Model: bizhub PRESS C7000/C7000P/C70hc/C6000/C6000L

Title: Release of bizhub PRESS C7000/C7000P/C70hc/C6000/C6000L mass production firmware Ver. 40

June 8, 2012

Fig.1 Image blur to sub-scan direction (FD)

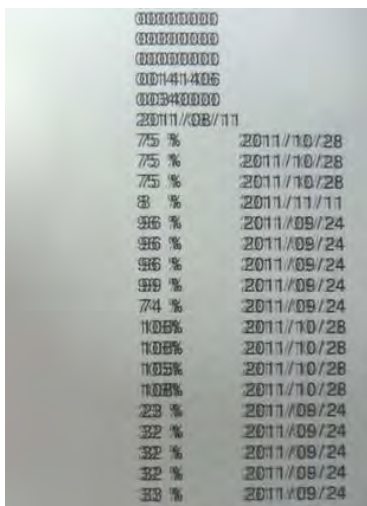
- 16) When setting the Multi Folder(Fold) Adjustment in French, Button name of each paper size is wrong.
(CSES: RIBEU_11003187)
 - 17) When copy and print jobs are combined and printed in duplex, the image quality changes before after combining jobs or duplexand simplex.
<Cause>
When prinnitng in duplex, a common screen was applied to copy job and print job.
=> Now, the screen originally set is used at printing each page.
(CSES: PEBJOD11007954) During continuous printing, when automatic tray change functions, polygon control becomes unstable and abnormal image such as image blur to sub-scan dirction (Fig. 1), Wavy image (Fig. 2), Slant ban (Fig. 3) appears.
Note: The paper feed direction of all the figures are all from right to left.
(CSES: PEBDFS11001229) (Special ROM I-GCM-32)
